PLANNING COMMISSION AGENDA

CITY OF DAYTON, MINNESOTA

ITEM:

Kwik Trip 1187

TRASH ENCLOSURE - SIDE ELEVATION

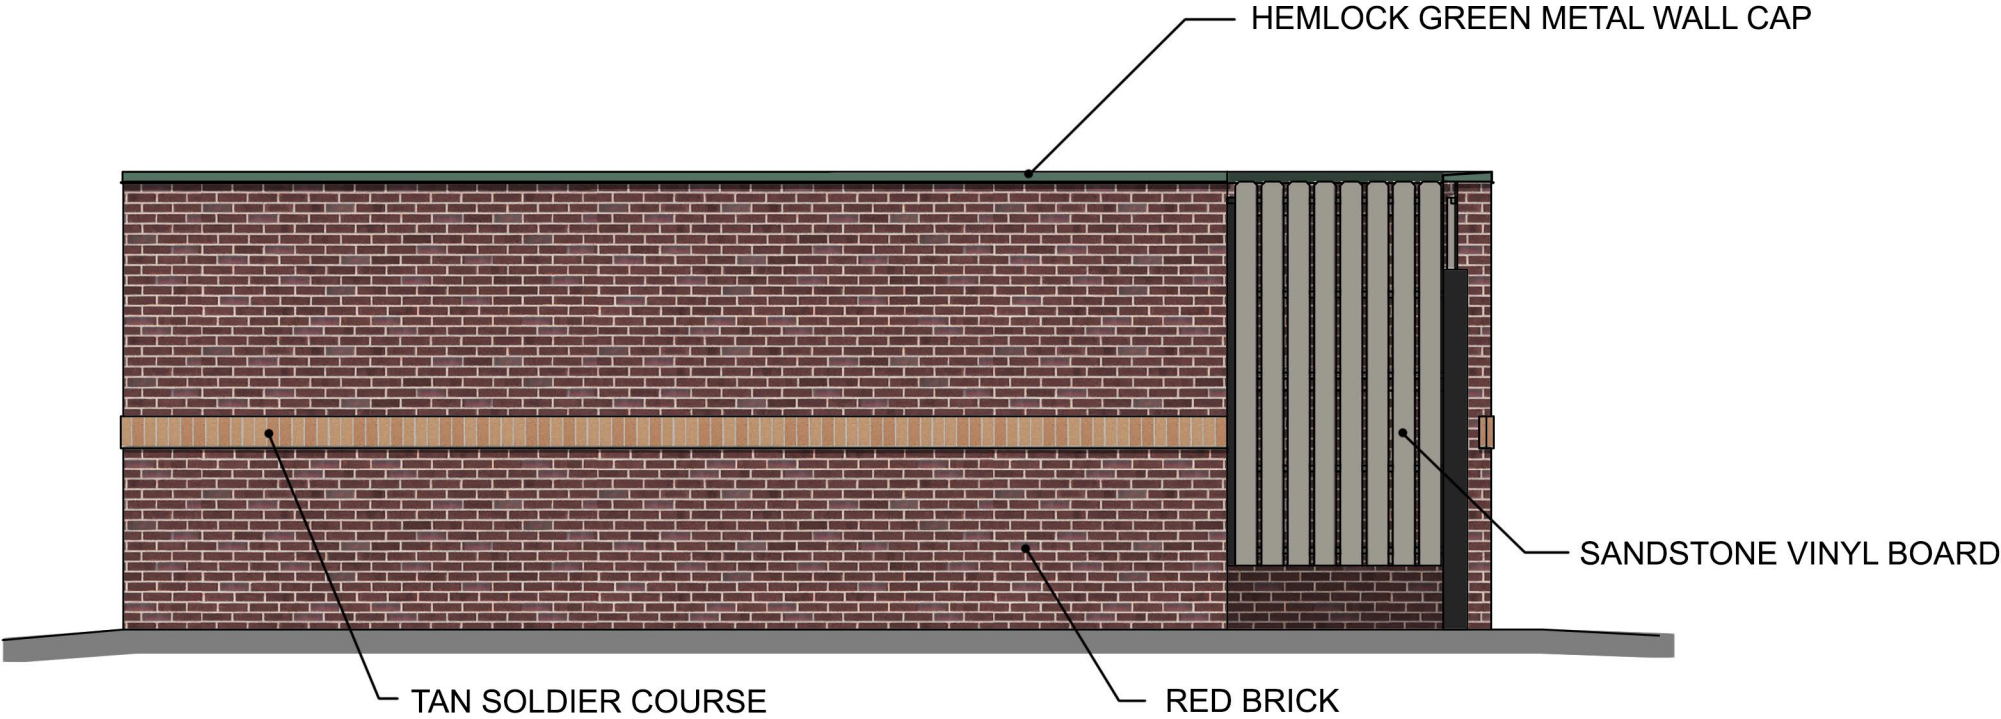
Accessory buildings are not permitted in Business Districts.¹⁰ The gator shed and trash enclosure are to be incorporated into the primary building.

Garage/trash Accessory Buildings are not permitted in Business districts. The building needs to be modified to incorporate the gator shed and trash enclosure.
